FCC ENVIRONMENT LIMITED

PWLLFAWATKIN LANDFILL SITE
SURFACE WATER MANAGEMENT PLAN
UPDATE 2021

Document Reference: WR7470 Final Rev 4
October 2021

DRAWN	DATE	APPROVED	DATE
ARK	06/06/2018	ARK	06/06/2018
SCALE	SHEET	DRAWING NUMBER	REVISION
1:1000	1	WR7470 01 01	G

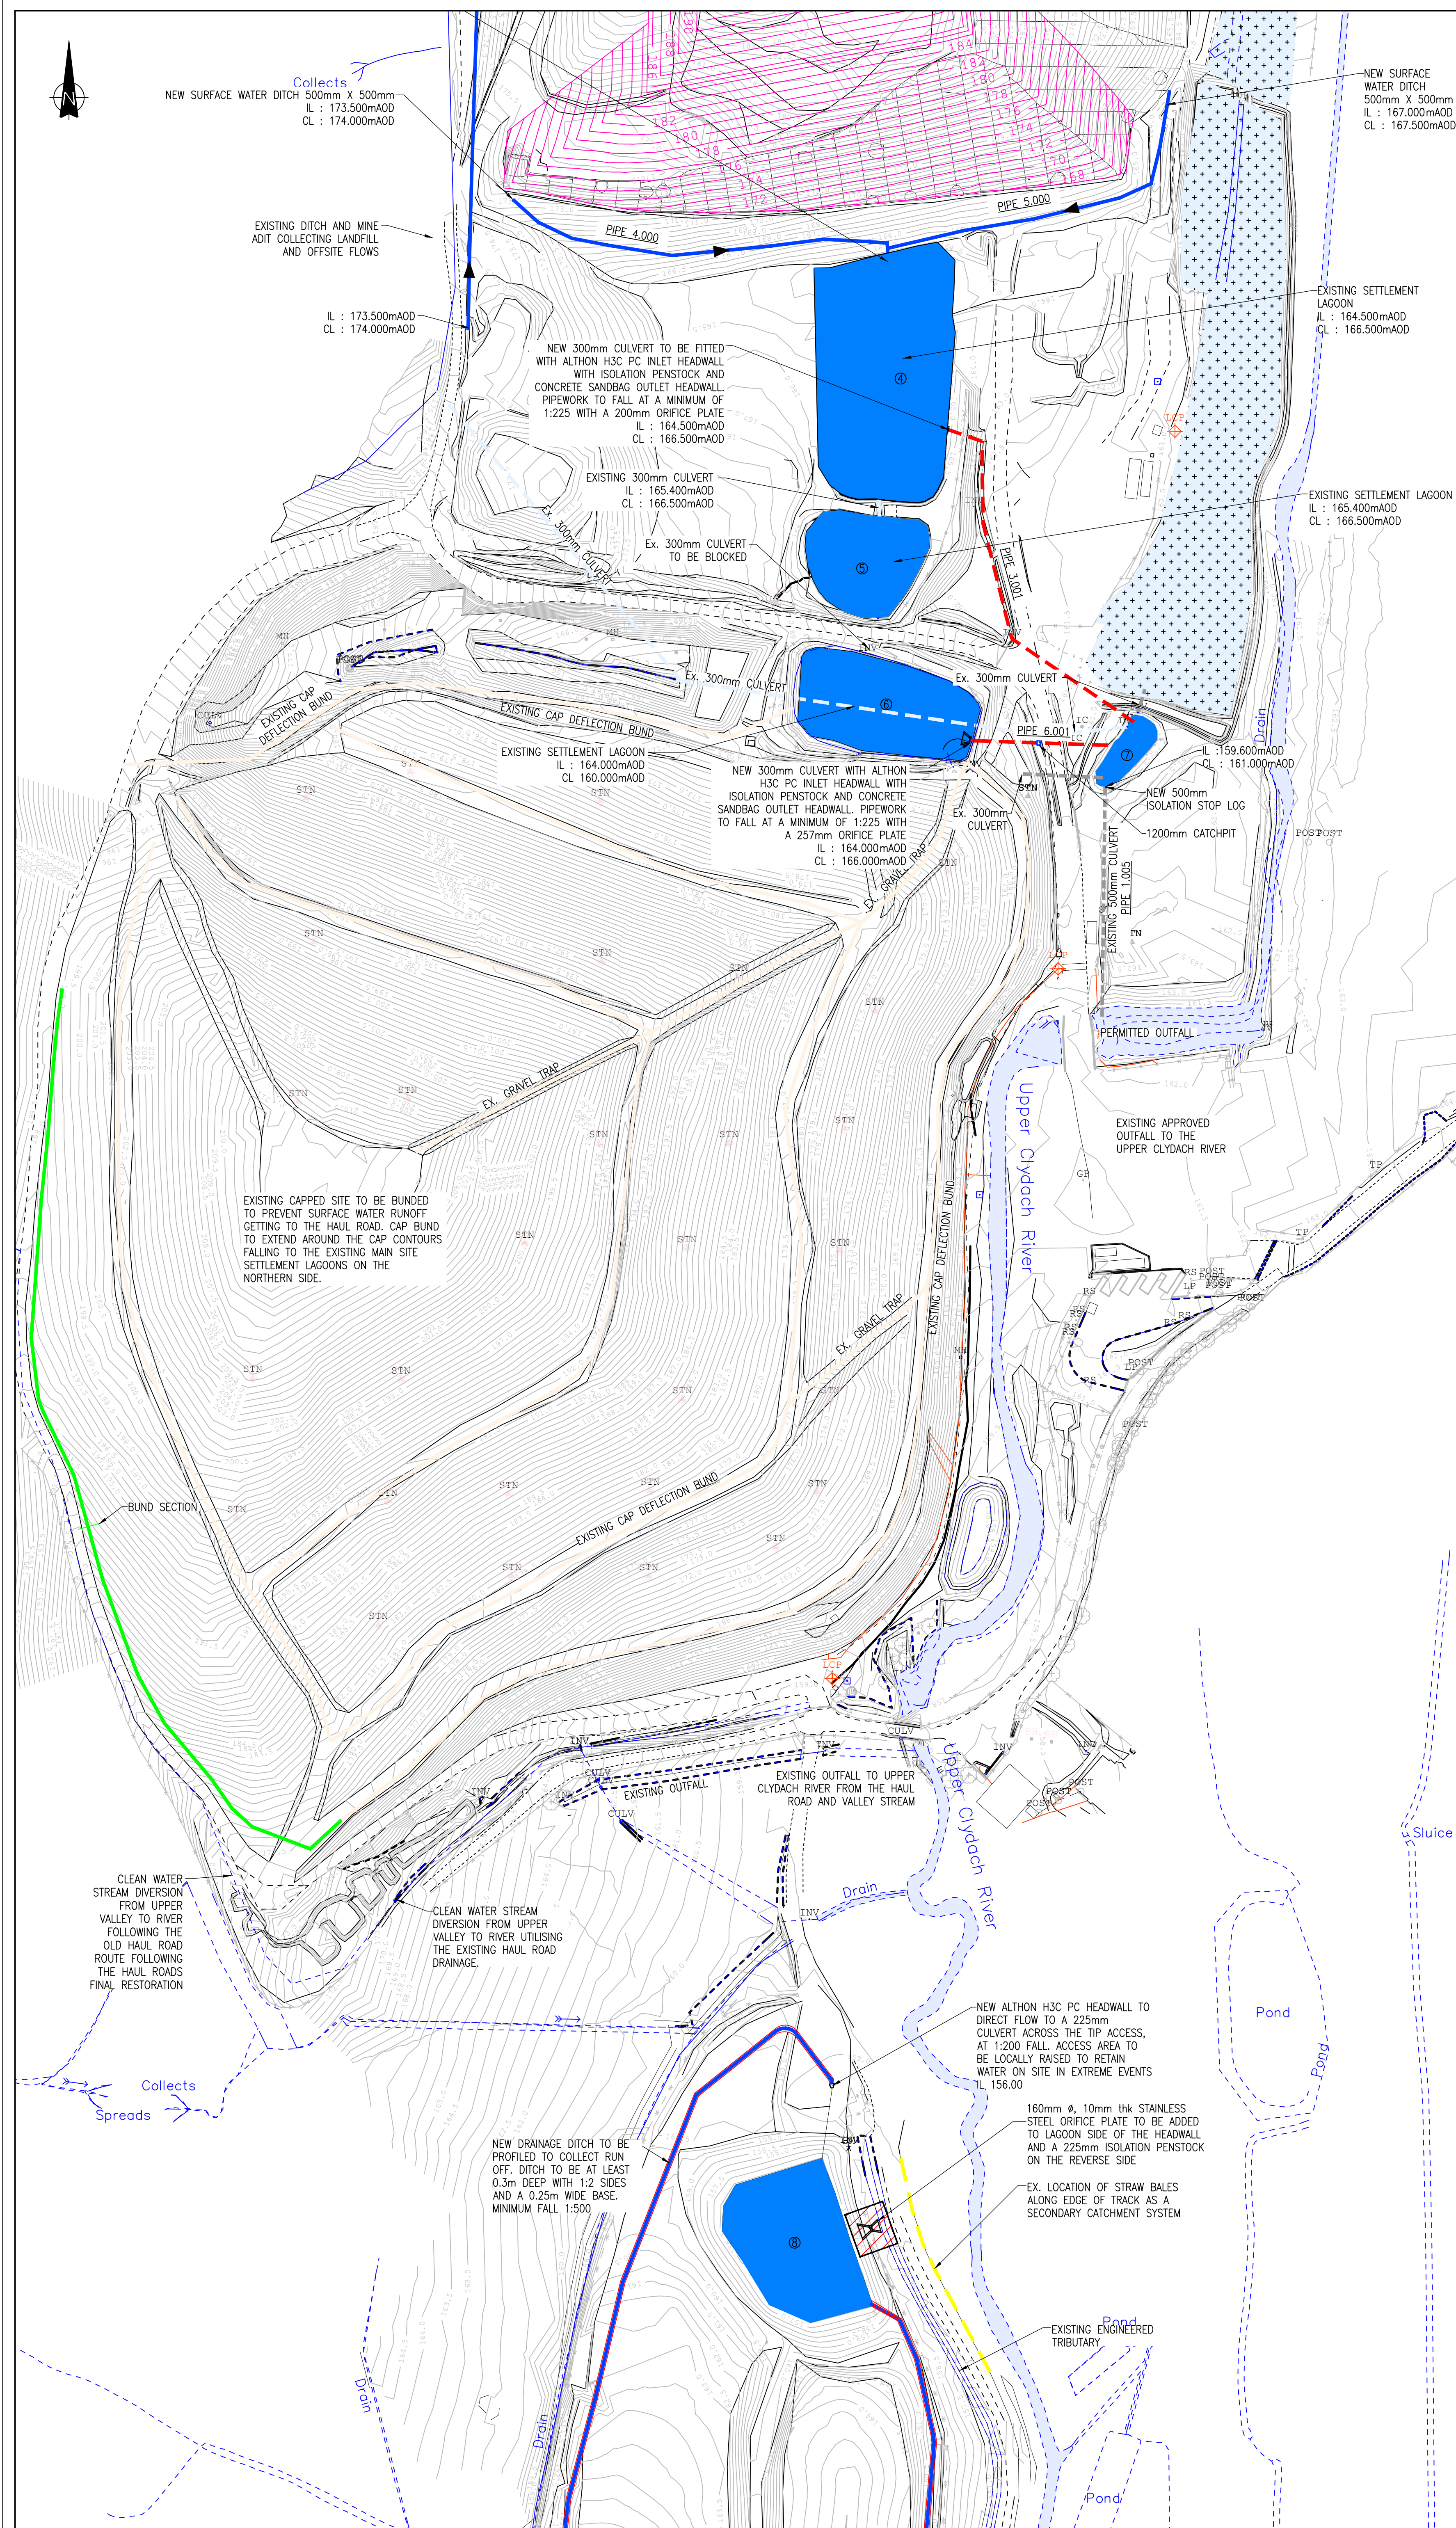
H	REVISED TOPO ADDED, PROPOSED WASTE CONTOURS ADDED, MINOR AMENDMENTS	07/10/21	M.C
G	INVERT LEVELS AND PIPE NUMBERS ADDED	23/09/19	M.C
F	PROPOSED LAGOON EXTENSION ADD NEW SURFACE WATER DITCH ADDED ON BUND OF REVISED CELL 5 DESIGN	16/08/19	M.C
E	WESTERN AND SOUTHERN DITCH MOVED DUE TO CELL 5	23/05/19	J.D
REV	DESCRIPTION	DATE	BY

DRAWN		DATE		APPROVED		DATE	
ARK		06/06/2018		ARK		06/06/2018	
SCALE		SHEET		DRAWING NUMBER		REVISION	
1:1000		2		WR7470 01 01		F

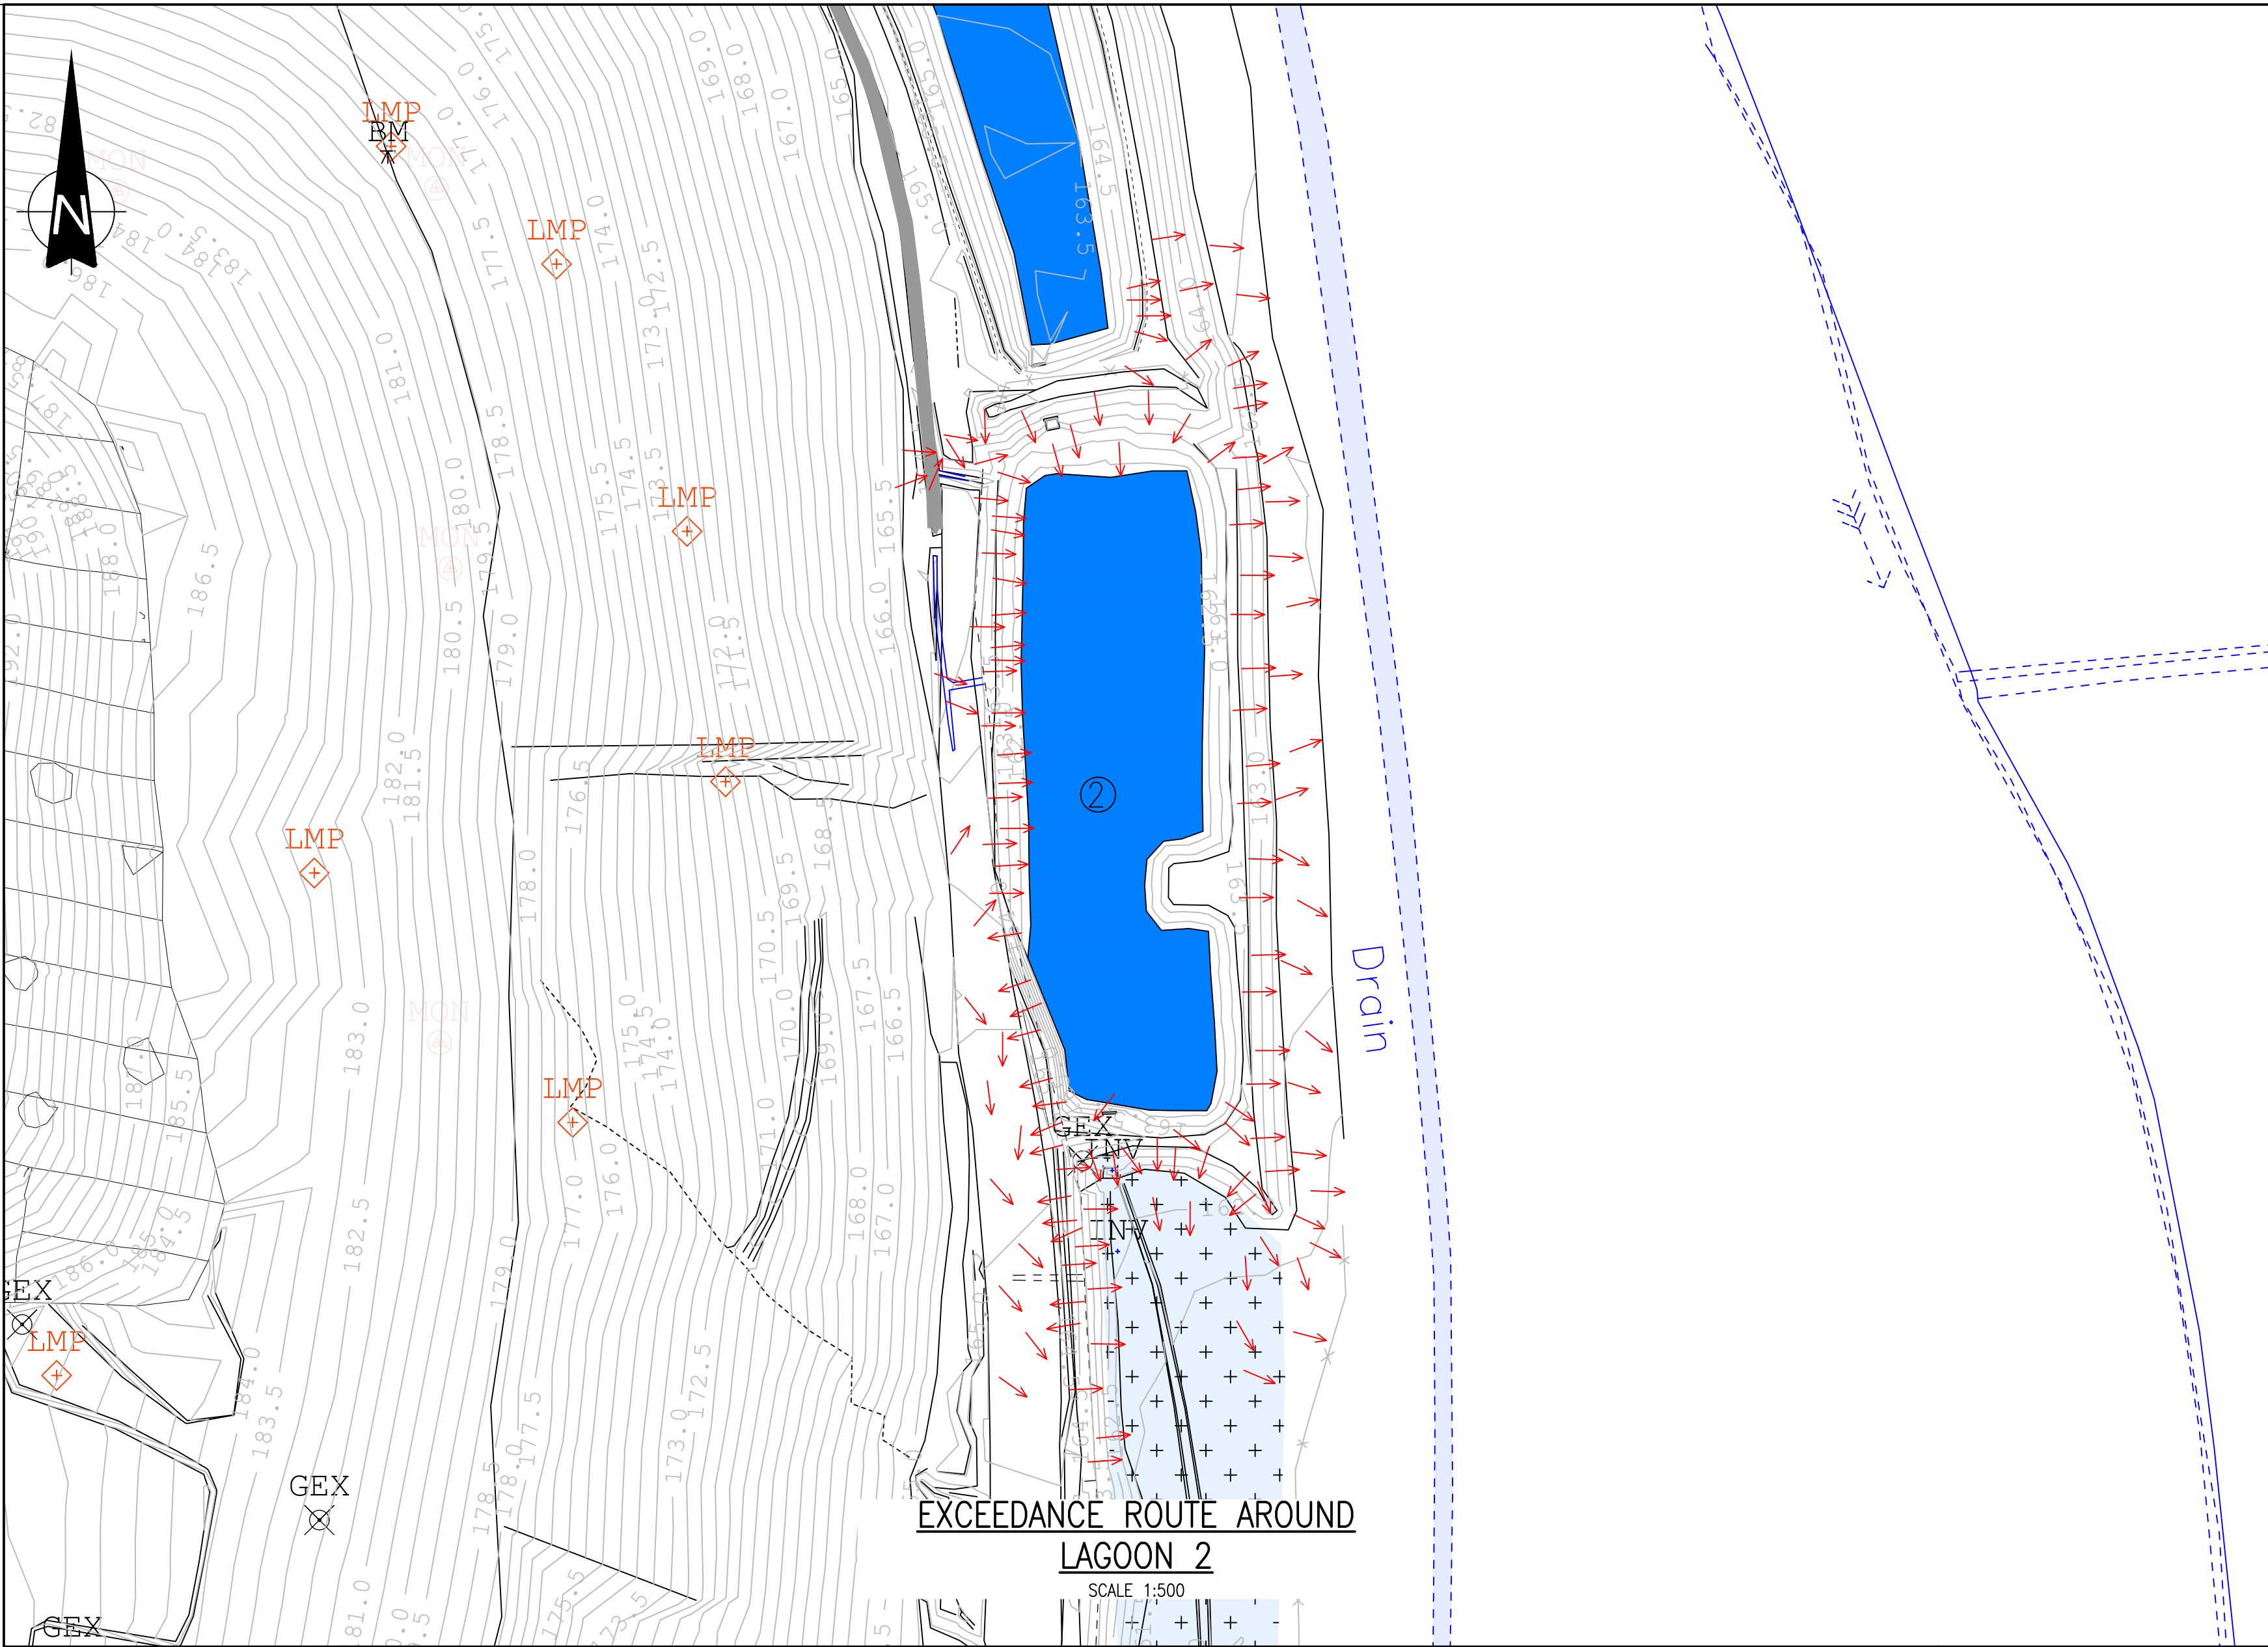
G	REVISED TOPO ADDED, PROPOSED WASTE CONTOURS ADDED, MINOR AMENDMENTS	07/10/21	M.C.
F	INVERT LEVELS AND PIPE NUMBERS ADDED	23/09/19	M.C.
E	PROPOSED LAGOON EXTENSION ADD. NEW SURFACE WATER DITCH ADDED ON BUND OF REVISED CELL 5 DESIGN	16/08/19	M.C.
REV	DESCRIPTION	DATE	BY
